Final Environmental Impact Report (Final EIR)

Los Angeles International Airport (LAX) Bradley West Project

Responses to Comments and Corrections and Additions to the Draft EIR

September 2009

BWP-PC00011-22

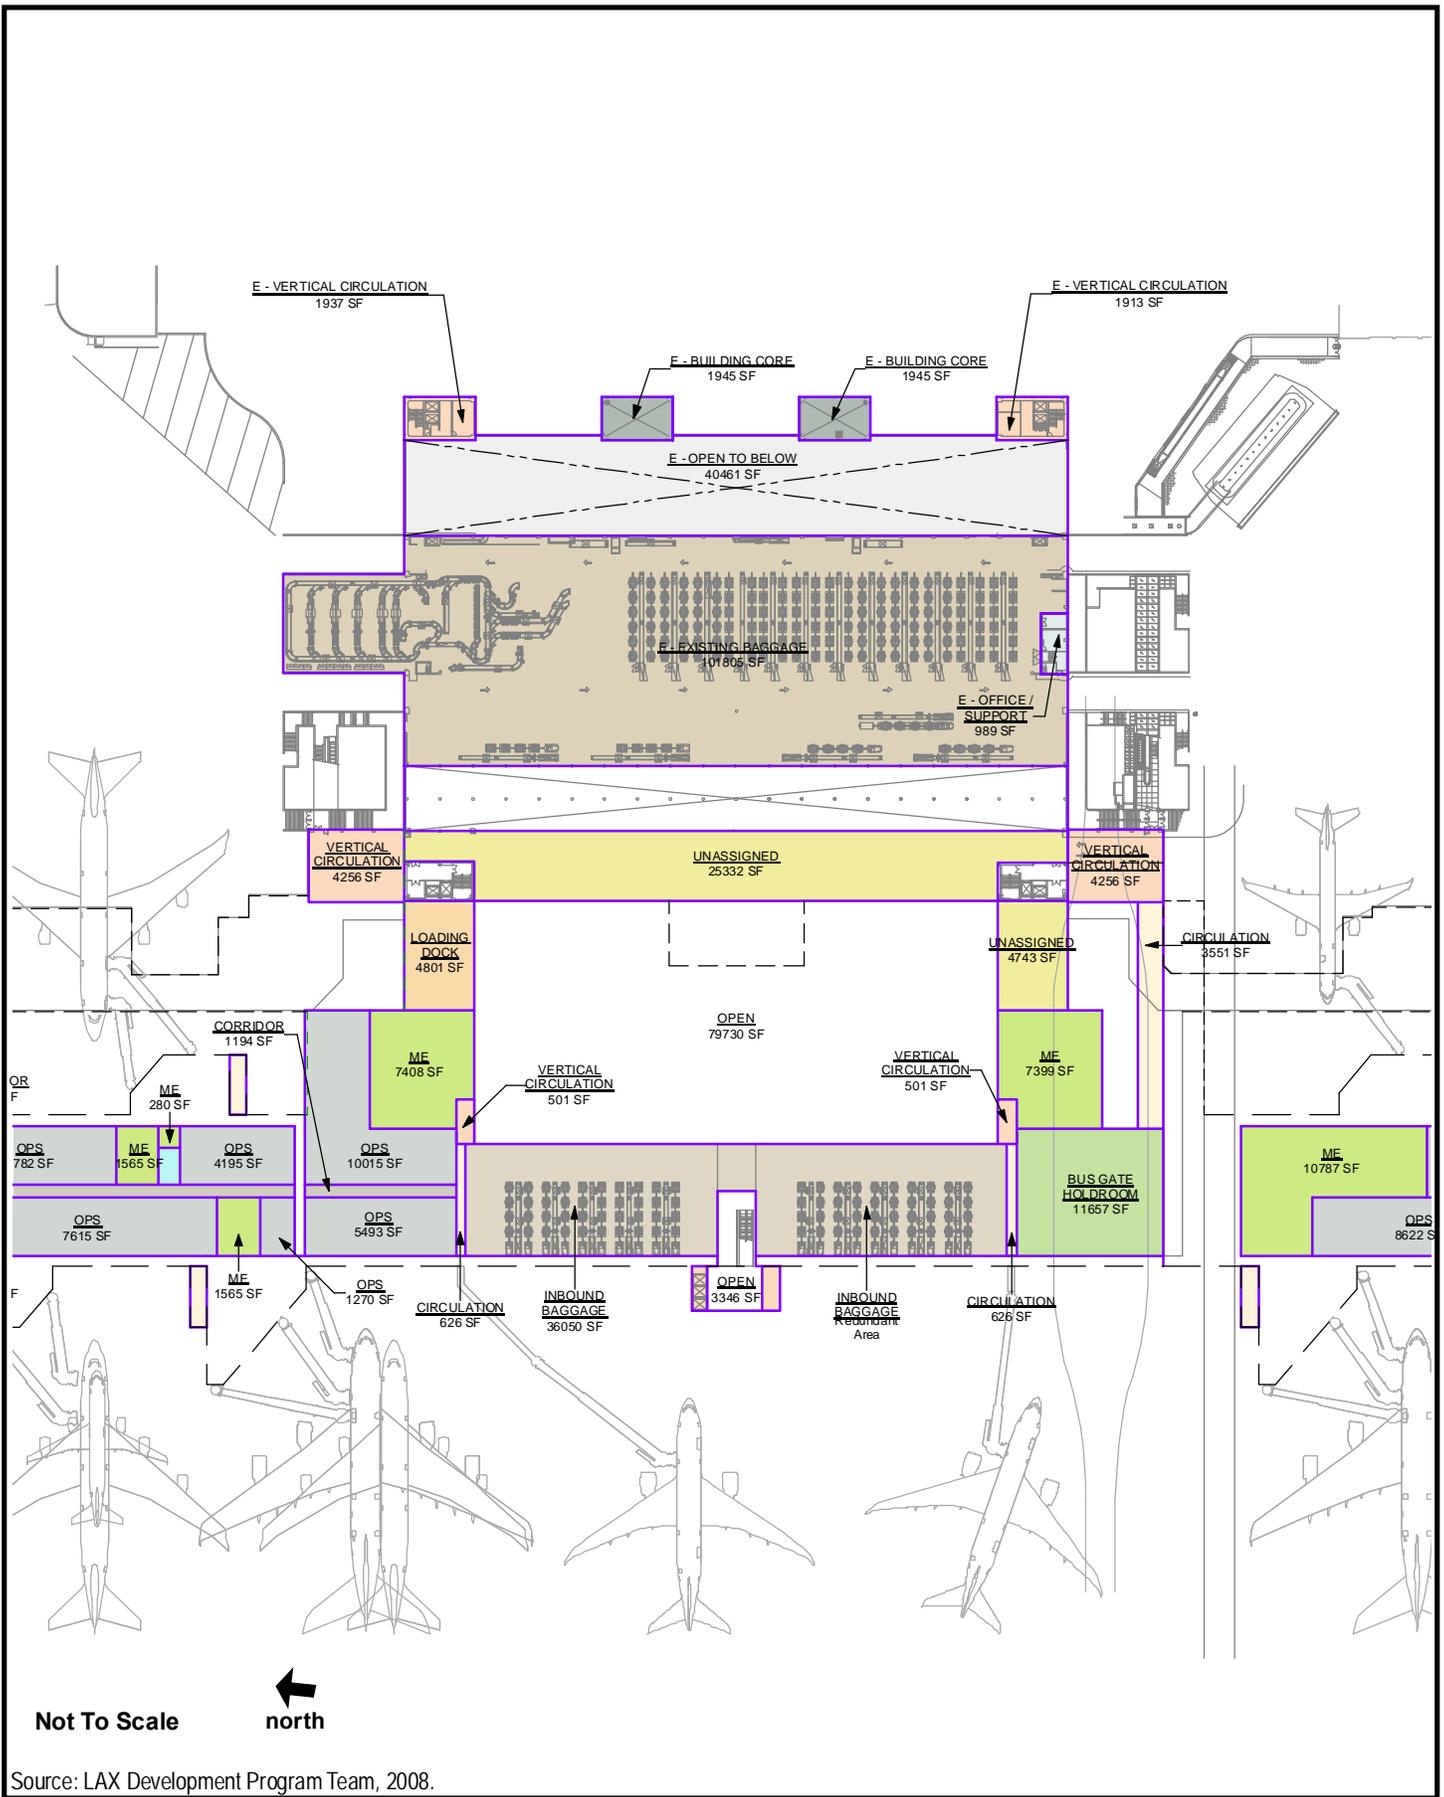
Comment: Figure 2.4a floor plan not readable.
Bradley West Core drawings are not readable.

Response: The comment is noted. To increase legibility, the following provides enlargements of the Bradley West Core areas depicted in Figures 2-4a through 2-4e of the Bradley West Project Draft EIR. In addition, a section view of the Bradley West Core, as included in Figure 2-5 of the Bradley West Project Draft EIR, with legible call-outs for certain uses added, is provided below.

LAX Bradley West Project Draft EIR **Existing (2008) Traffic Volumes** **Figure 4.2-3c**

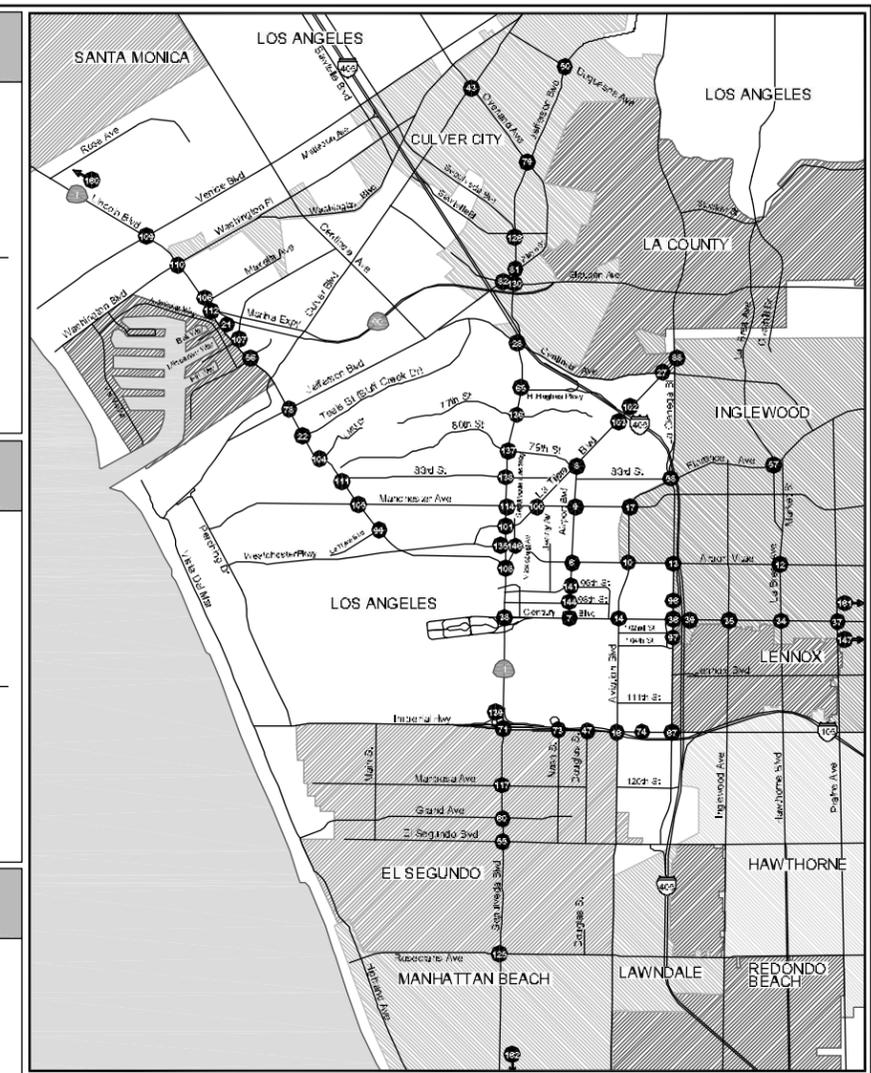
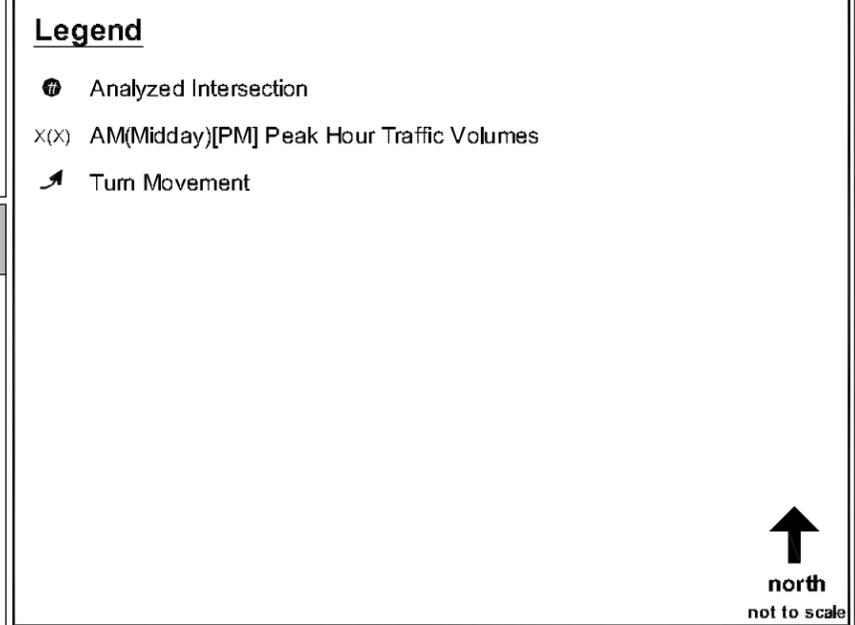
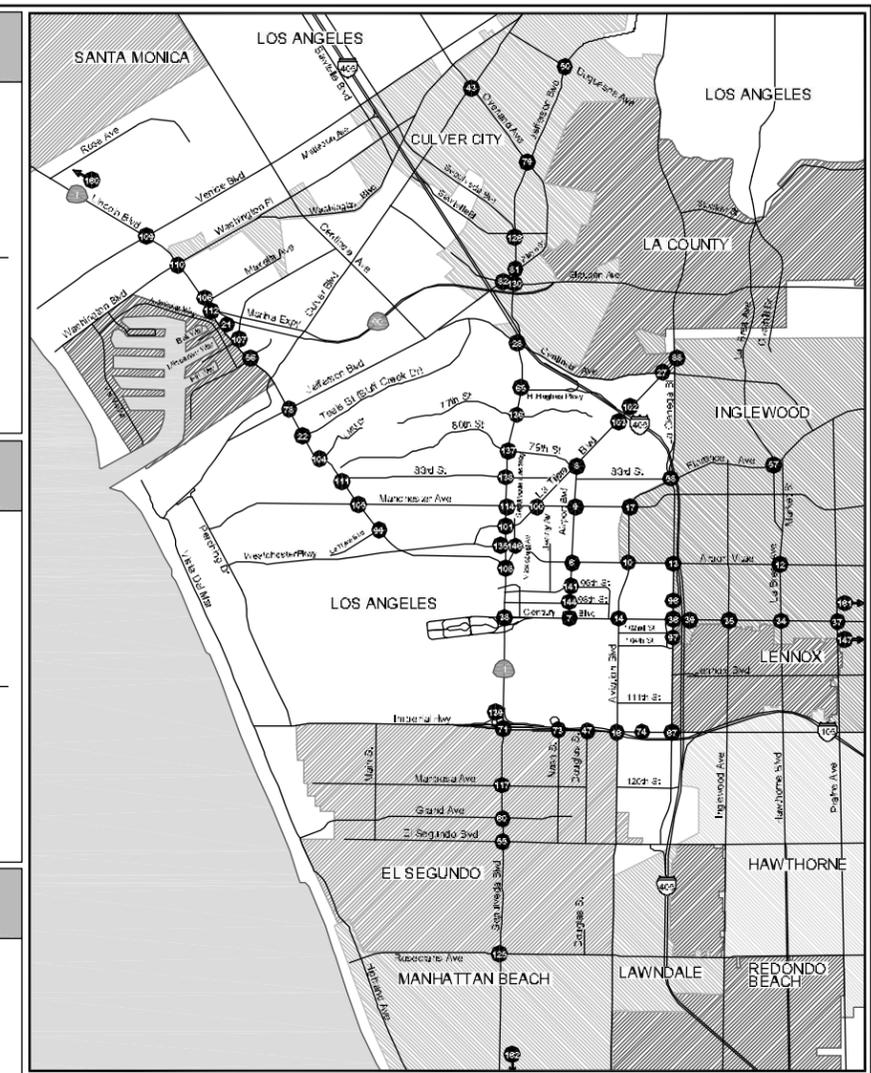
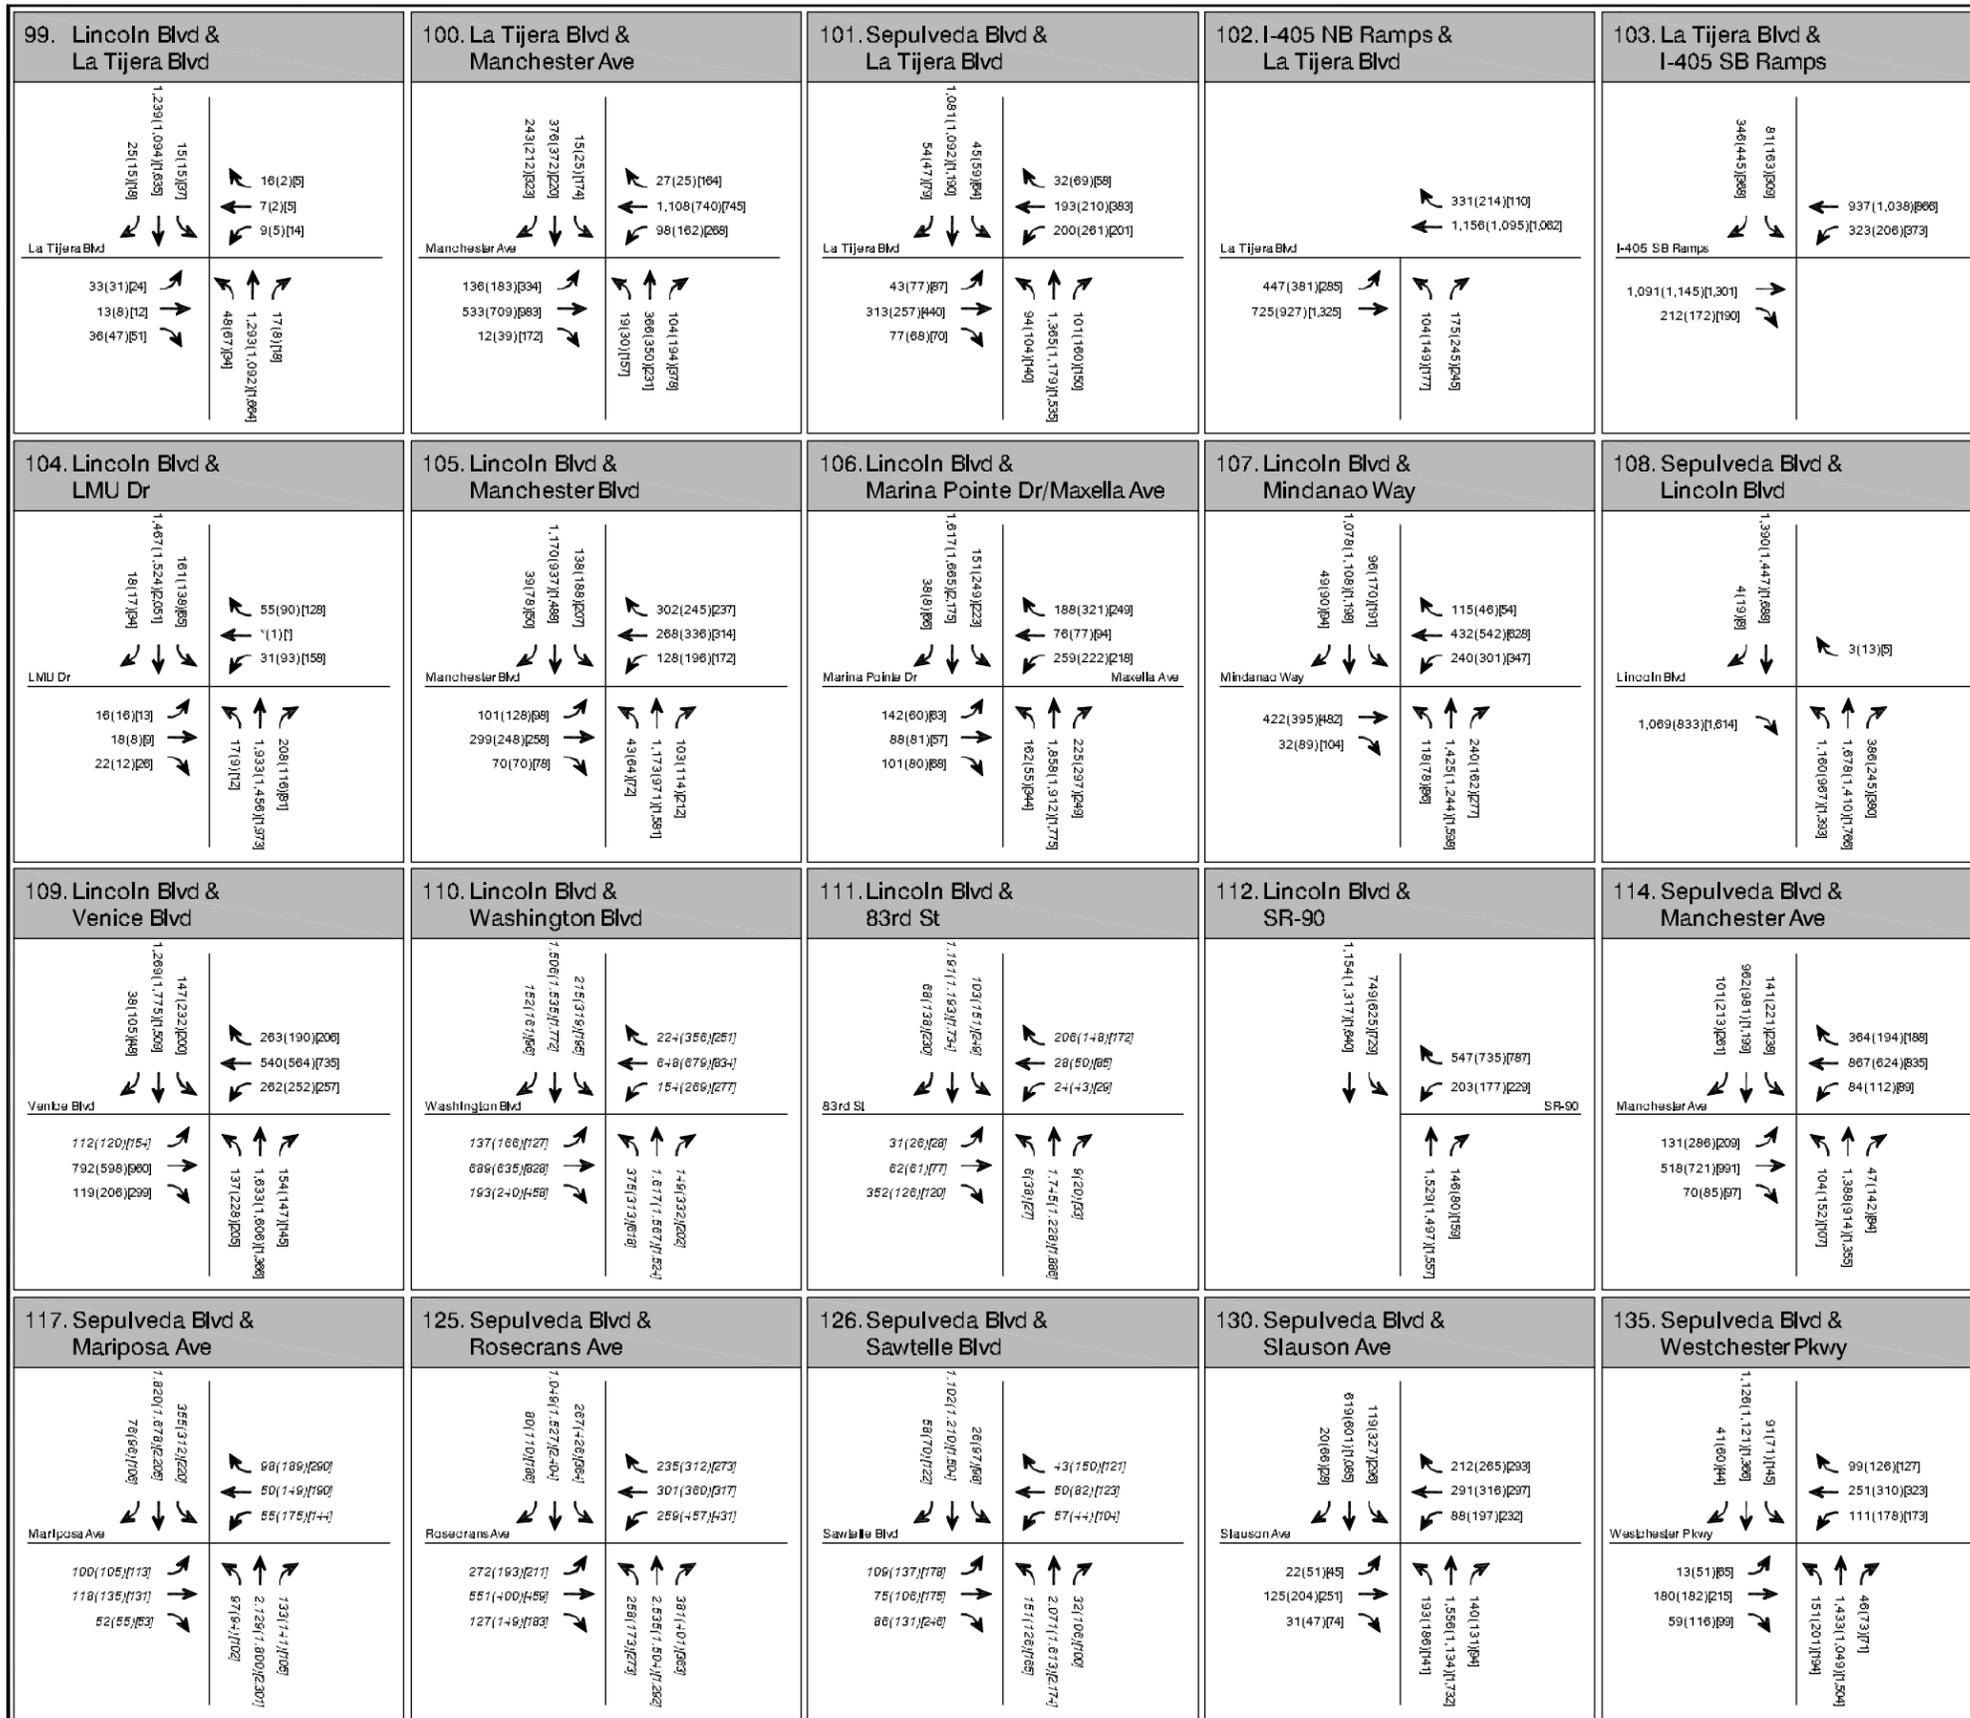
Comment: Volume 4, Appendix C-5, page 8, Lincoln Boulevard and Venice Boulevard (Intersection #109): The eastbound AM left-turn vehicle count for Existing Conditions does not match the count shown in Volume 1, Figure 4.2-3c; similar errors occur with the Mid-day and PM peak eastbound left-turn counts. All intersection capacity analysis effected by these errors should be revised accordingly and corresponding mitigation measures and potential improvements should be identified and evaluated for any anticipated significant impacts. If similar errors occur for other project scenarios (e.g. "No Project," "Plus Project" etc.) then capacity analysis calculations and any resulting potential mitigation measures should also be revised accordingly.

Comment: Volume 4, Appendix C-5, page 9, Lincoln Boulevard and Washington Boulevard (Intersection # 110): The AM peak vehicle counts for Existing Conditions do not match those shown in Volume 1, Figure 4.2-3c; similar errors occur with the Mid-day and PM peak vehicle counts. All intersection capacity analysis effected by these errors should be revised accordingly and corresponding mitigation measures and potential improvements should be identified and evaluated for any anticipated significant impacts. If similar errors occur for other project scenarios (e.g. "No Project," "Plus Project" etc.) then capacity analysis calculations and any resulting potential mitigation measures should also be revised accordingly.

Comment: Volume 4, Appendix C-5, page 9, Lincoln Boulevard and 83rd Street (Intersection #111): The AM peak vehicle counts for Existing Conditions do not match those shown in Volume 1, Figure 4.2-3c; similar errors occur with the Mid-day and PM peak vehicle counts. All intersection capacity analysis effected by these errors should be revised accordingly and corresponding mitigation measures and potential improvements should be identified and evaluated for any anticipated significant impacts. If similar errors occur for other project scenarios (e.g. "No Project," "Plus Project" etc.) then capacity analysis calculations and any resulting potential mitigation measures should also be revised accordingly.

Response: The typographical error is noted. In response, the eastbound AM, Mid-day and PM left-turn volumes for the Lincoln Boulevard and Venice Boulevard intersection in Figure 4.2-3c on page 4-107 of the Bradley West Project Draft EIR have been revised. Please see Chapter 3, Corrections and Additions to the Bradley West Project Draft EIR. The volumes used in the existing (2008) traffic conditions intersection analysis match the existing counts (as shown in Appendix C-4) for all analyzed periods; therefore, the existing (2008) traffic conditions analysis is not affected and no additional revisions are required.

Response: The typographical error is noted. In response, the volume figure for the Lincoln Boulevard and Washington Boulevard intersection in Figure 4.2-3c on page 4-107, Figure 4.2-4c on page 4-141, and Figure 4.2-5c on page 4-149 of the Bradley West Project Draft EIR has been revised. Please see Chapter 3, Corrections and Additions to the Bradley West Project Draft EIR. However, the revised Mid-day southbound through volume at the Lincoln Boulevard and Washington Boulevard intersection does not match the vehicle counts because the volume was adjusted to be consistent with the traffic volumes at nearby intersections. As stated on page 4-90 in Section 4.2 of the Bradley West Project Draft EIR, traffic volumes, counted or forecasted, are balanced to ensure a reasonable amount of vehicles are either gained or lost between adjacent intersections. The volumes used in the intersection analysis for all scenarios match the revised volumes for all periods; therefore, the intersection analysis is not affected and no additional revisions are required.

Response: The typographical error is noted. In response, the volume figure for the Lincoln Boulevard and 83rd Street intersection in Figure 4.2-3c on page 4-107, Figure 4.2-4c on page 4-141, and Figure 4.2-5c on page 4-149 of the Bradley West Project Draft EIR has been revised. Please see Chapter 3, Corrections and Additions to the Bradley West Project Draft EIR. However, the revised AM and Mid-day northbound and southbound through volumes at the Lincoln Boulevard and 83rd Street intersection do not match the vehicle counts because the volume was adjusted to be consistent with the traffic volumes at nearby intersections. As stated on page 4-90 in Section 4.2 of the Bradley West Project Draft EIR, traffic volumes, counted or forecasted, are balanced to ensure a reasonable amount of vehicles are either gained or lost between adjacent intersections. The volumes used in the intersection analysis for all scenarios match the revised volumes for all periods; therefore, the intersection analysis is not affected and no additional revisions are required.
